NOV_SCE_ATJ_ 20211209-01

Southern California Edison

NOTICE OF VIOLATION

Energy Safety Inspection Report

| Item6GImg1: Overall pole | Item6GImg2: Pole ID |

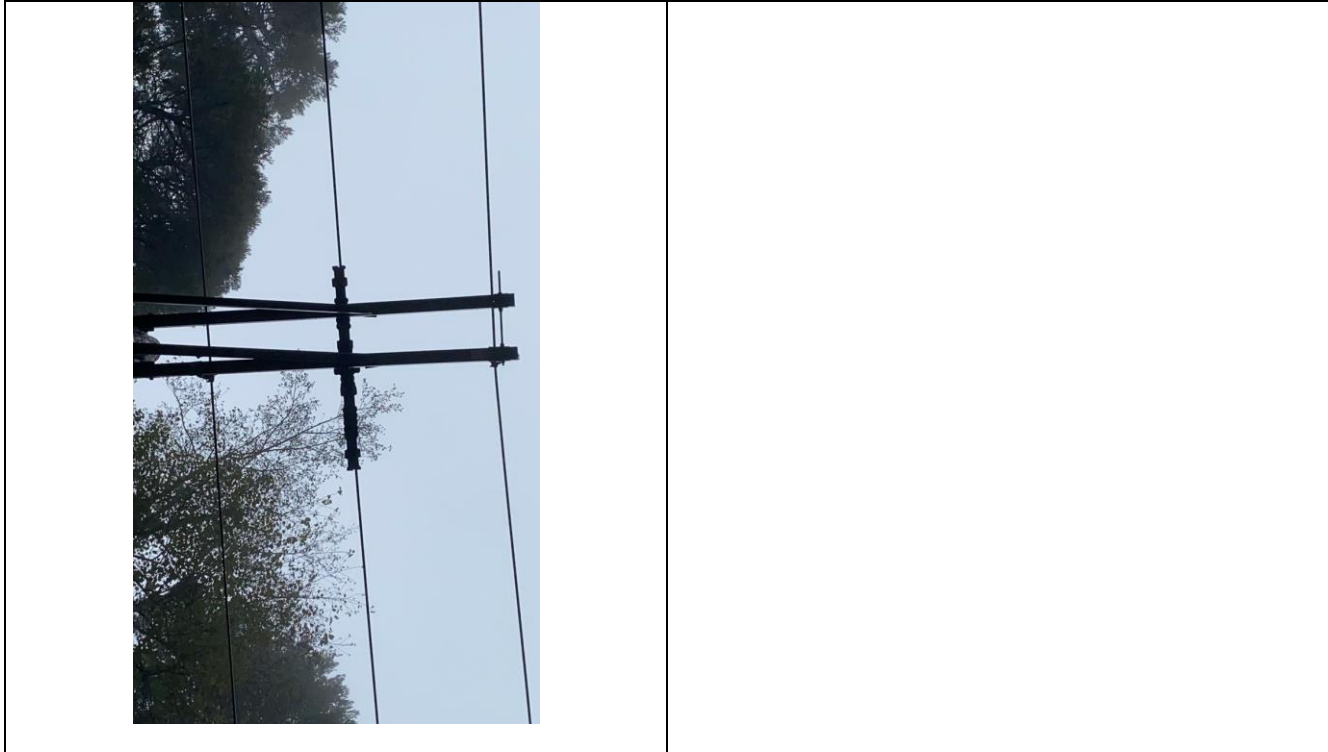
| Item | Structure ID | HFTD | Initiative Number | Violation Type | Severity | Violation Description |
|------|--------------|--------|-------------------|-----------------------|----------|--|
| 15 | 4421488E | Tier 3 | 7.3.3.3.1 | Adherence to Protocol | Minor | Failure to install vibration dampers on a span |
| 16 | 4421488E | Tier 3 | 7.3.3.3.1 | Adherence to Protocol | Minor | Failure to install vice top polymer pin type insulators with nylon inserts |

| Item6IA1Img1: No vibration dampers | |

| Item6IA2Img1: Overall view of insulators with cover. Insulators should be vice top polymer pin type insulators with nylon inserts | Item6IA2Img2: Close up of insulator from previous image |
